Access Compliance Report

Public Rights-of-Way

Intersection ID: 18605	Main Street: MOCKINGBIRD_LN	Cross Street: PARK_RD	Location: SW
ADA ID: C103B1CC8810	Ramp Type: PerpDiag	Initial Pass/Fail: Fail	Overall Compliance: No
Severity Score: 10			
Codes/Mitigation Info/Possible Solution		Field Measurements/Component Compliance

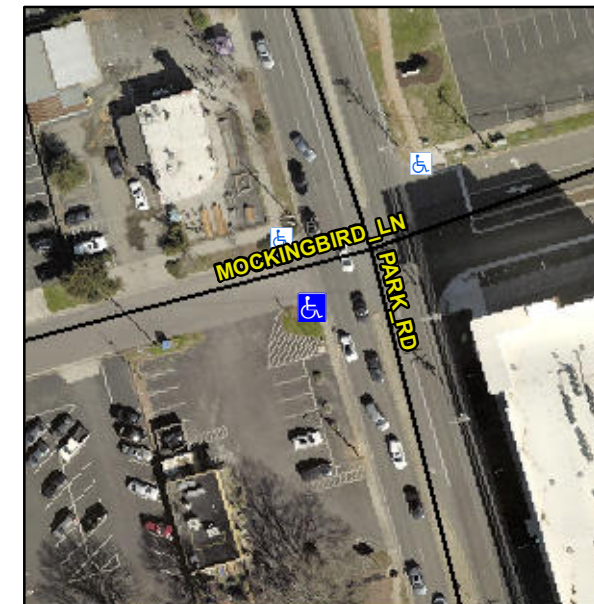
R304.5.1, R304.5.3

Compliance	Description	Data	Compliance	Description	Data
N/A	Ramp Length (in)	54.0	Yes	Ramp Slope (%)	5.7
No	Ramp Width (in)	47.0	No	Ramp XSlope (%)	3.2
N/A	Flare Type LT	N/A	N/A	Flare Type RT	N/A
N/A	Flare Slope LT (%)	N/A	N/A	Flare Slope RT (%)	N/A
N/A	Flare Traversable LT?	N/A	N/A	Flare Traversable RT?	N/A
N/A	Landing Length (in)	N/A	N/A	DWS Provided?	N/A
N/A	Landing Width (in)	N/A	N/A	DWS Contrast?	N/A
N/A	Landing Slope (%)	N/A	N/A	DWS Length (in)	N/A
N/A	Landing X Slope (%)	N/A	N/A	DWS Full Width?	N/A
N/A	Landing Curb? (Y/N)	N/A	N/A	DWS Offset (in)	N/A
N/A	Shared Landing?	N/A			
N/A	Gutter Ponding?	N/A	N/A	Gutter Slope (%)	N/A
N/A	Gutter Lip Ht (in)	N/A	N/A	Gutter X Slope (%)	N/A
N/A	Painted X Walk1?	No	N/A	Painted X Walk2?	No
	X Walk 1 Direction	To E		X Walk 2 Direction	To N
N/A	X Walk 1 Width (in)	N/A	N/A	X Walk 2 Width (in)	N/A
	X Walk 1 Slope (%)	1.3		X Walk 2 Slope (%)	3.4
	X Walk 1 X Slope (%)	3.8		X Walk 2 X Slope (%)	0.8

Remove & Replace Curb Ramp With Two New Directional Ramps or Equivalent.
